In Reply Refer To: HSSD/WZ-251

Thank you for your letter of October 31, 2006, requesting the Federal Highway Administration (FHWA) acceptance of your company's QMBC Gate channelizing system as a crashworthy traffic control device for use in work zones and permanent installations on the National Highway System (NHS). Accompanying your letter was a report of the crash testing you conducted and video of the test. You requested that we find this device acceptable for use on the NHS under the provisions of the National Cooperative Highway Research Program (NCHRP) Report 350 "Recommended Procedures for the Safety Performance Evaluation of Highway Features."

Illustration D-4

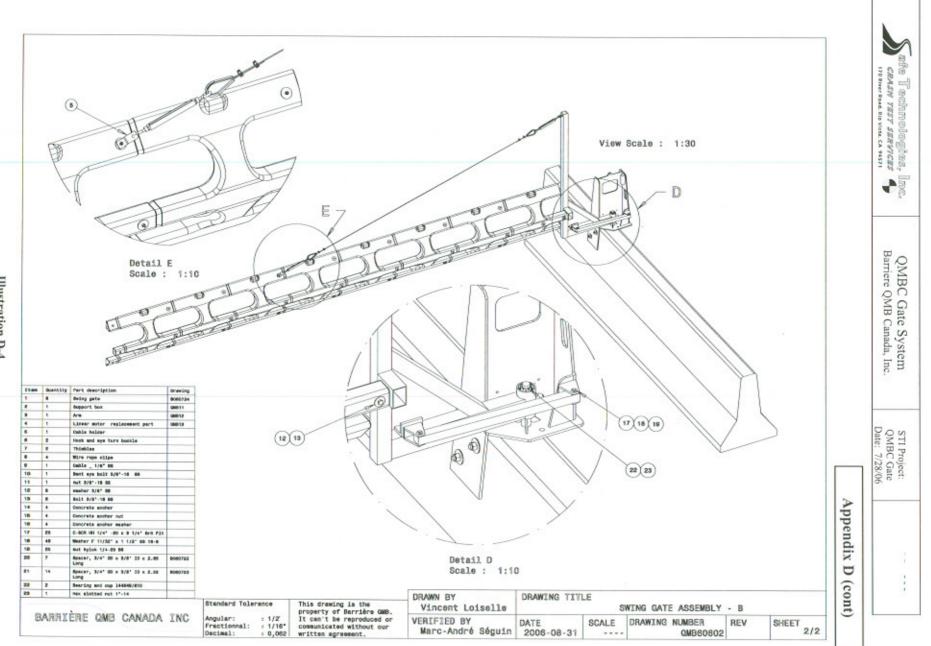
sequence, a required spacing of at least two Gate lengths is recommended to separate the Gate bases. Each plastic Gate is fabricated using two foot modular sections and an optional one foot end section made of high density polyethylene. Assemblies may vary in length from 2 to 24 feet. A drawing of the Gate configurations is enclosed.

In summary, the QMBC Gate channelizer meets the appropriate evaluation criteria and may be used at all appropriate locations on the NHS when selected by the contracting authority, subject to the provisions of Title 23, Code of Federal Regulations, Section 635.411, as they pertain to proprietary products.
